April 9, 2003
LIC-03-0053

SUBJECT: Response to Request For Additional Information (RAI), Related to Exemption Request from the Requirements of 10 CFR 50, Appendix R, Section III.G.2 for Room 19 at Fort Calhoun Station (FCS)

**Response to NRC Request for Additional Information
For OPPD
Exemption Request from the Requirements of 10 CFR 50, Appendix R,
Section III.G.2 for Room 19 at FCS**

ATTACHMENT 2
PAGE 1
FORT CALHOUN STATION
FIRE AREA 32

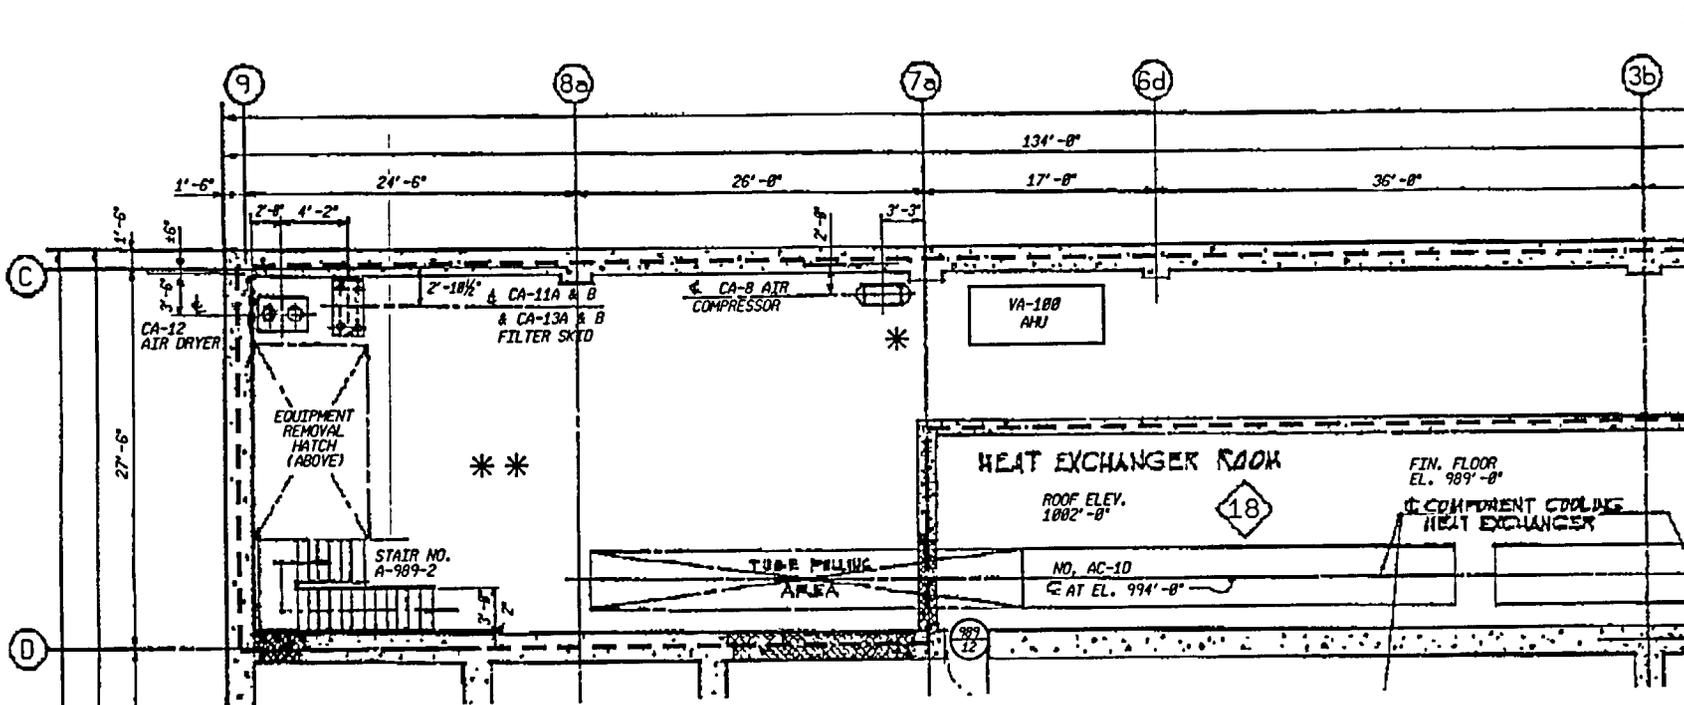
The 3-dimensional Figure 1 attached in the November 8, 2002, exemption request (exemption request) does not provide the appropriate level of detail for staff review. Please submit a revised drawing (P&ID) which shows the following for Fire Area (FA) 32:

- **room dimensions (including height),**
- **location of compressors and auxiliary feedwater pumps,**
- **fire doors and fire barriers,**
- **the location of cable trays identified in exemption request (identifying both power and control cables),**
- **ventilation system details, and**
- **locations of any fixed and/or transient ignition sources.**

Refer to Attachment 2 for additional clarification on room dimensions, major equipment locations, fire door and barrier designations, and the location of fixed and potential transient ignition sources. Ventilation for FA 32 is provided by supply and exhaust fans located in a different fire area. Approximately 2,200 cubic feet/minute (cfm) of non-cooled air is provided to the room with ductwork running along the west (supply) from columns 1a to 4a and east (exhaust) from columns 1a to 6d of the area. Approximately 3,400 cfm of cooled air is also provided for the room by air handling unit, VA-100, which is shown in Attachment 2. OPPD requests the NRC refer to the 3-dimensional Figure 1 submitted on November 8, 2002 for location of cable trays identified in the exemption request. This level of detail for the cable trays is difficult to display on plan view drawings and is much better depicted in the 3-dimensional color-coded figure previously submitted. Additionally, OPPD recommends that the NRC refer to the June 27, 2002 Public Meeting Presentation materials (which OPPD provided to the NRC) that depict detailed information within each zone. The Public Meeting Presentation materials contain color-coded cable trays with redundant tray designations, which may be helpful to the reviewers. Finally, OPPD recommends that the reviewers conduct a site visit to inspect FA 32. A site visit will help the reviewers better understand the layout and physical attributes of the fire area.
